## Vierra Reinforcement Project Data Request Set No. 3 – Additional PG&E Responses January 25, 2019

An initial set of responses to Data Request No. 3 was submitted on December 18, 2018. This set of responses addresses the remaining requests of AE-1, CR-2, CR-3, PD-11, PD-13, PD-14, and USS-2.

Visual Simulation of Proposed Project

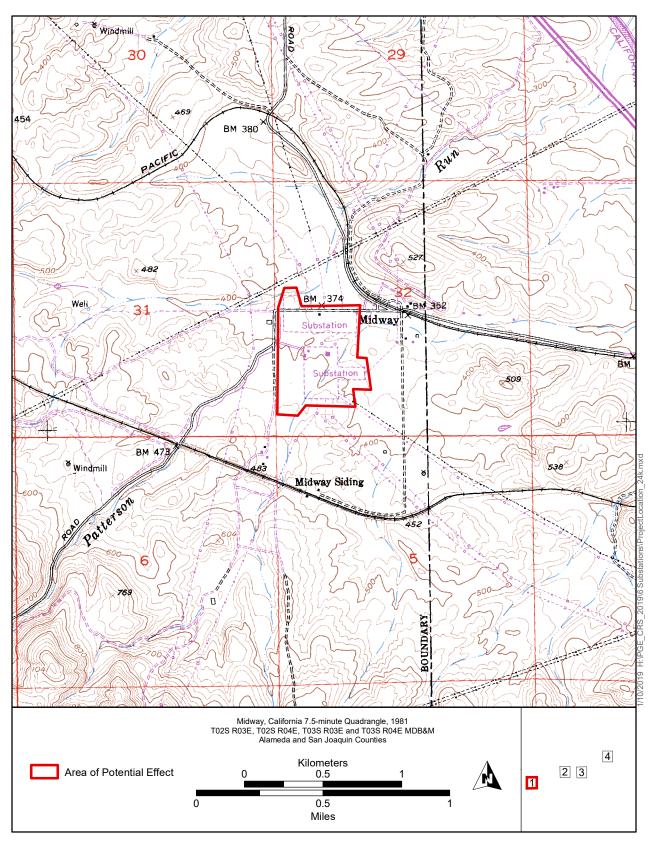
It does not appear that Figure 3.1-3b in Section 3.1, Aesthetics of the PEA showing a photo simulation of the expanded Vierra Substation includes the new 100-foot microwave tower (lattice) in proper proportion to the surrounding towers. Please update the photo simulation to include the new tower in proper comparison to the poles surrounding it. Also, Figure 2.0-7 in Section 2, Project Description of the PEA showing a profile drawing of the expanded Vierra Substation does not appear to include the new 100-foot microwave lattice tower. If the tower is not included in the profile drawing, please update to include the new tower.

**PG&E Response:** The revised simulation of the expanded Vierra Substation (Figure 3.1-3b) is attached. Although substation profile drawings do not typically include microwave towers and transmission poles, we have added those components in a revised profile drawing (Figure 2.0-7). The drawing and simulation show the height of the microwave tower as 120 feet. The tower is located at the northeast corner of the expansion area. A survey path analysis conducted in December 2018 identified that the tower would need to be approximately 120 feet in height due to the presence of a eucalyptus tree along the microwave path. If the landowner agrees the tree can removed or trimmed, the microwave tower could be reduced to approximately 100 feet.

## Proposed Locations of Microwave Monopoles (Approximate, Preliminary, and Subject to Change)

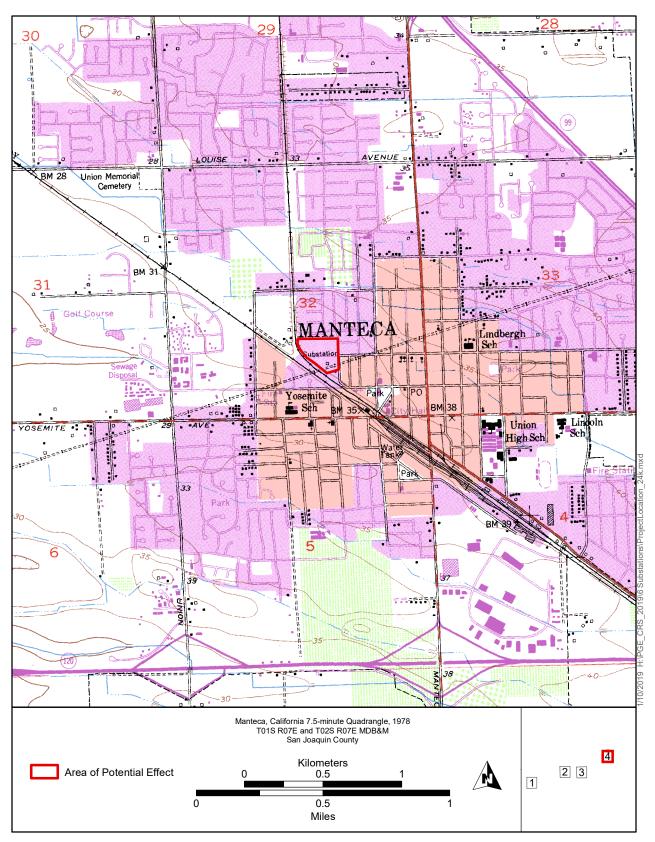
- 5. Please provide a site map showing the location of construction disturbance, including new towers and all temporary staging areas.
- 6. Please identify and provide the estimated quantity of soil or other solid waste and wastewater to be generated during construction of remote end work, and where it will be disposed (e.g. Vasco Road Landfill).
- 7. For the Kason, Manteca, and Tracy substations, please identify any soil or water contamination that could be encountered during subsurface excavation and mitigation required, if any.

# The Project Description section of the PEA mentions the construction of microwave monopoles at the Manteca, Kasson, and Tracy substations (page 2.0-24). Construction of those monopoles would require construction of 11 feet square by 4 feet deep foundations. However, no details about the specific location of the monopoles was provided (apart from being installed within the existing fence line). Also, no information was provided regarding the sources of water for foundation construction, or the

**PG&E Response:** A site map showing the approximate location of the monopoles to be installed at Kasson, Tracy, and Manteca substations is attached. The location of staging with the substation yards will be identified at the time of construction and subject to concurrent activity within the yards and safe working conditions.

- Site maps showing the approximate locations of microwave monopoles at Manteca, Kasson and Tracy substations are attached.
- Minimal water use (less than 100 gallons) is anticipated for the work at Manteca, Kasson and Tracy substations. The sources of water at those locations is not known at this time.
- The minimal amount of water used during construction will infiltrate into the ground at the location of use. Should dewatering be required during foundation construction, it will be removed from the site and/or tested prior to discharge.
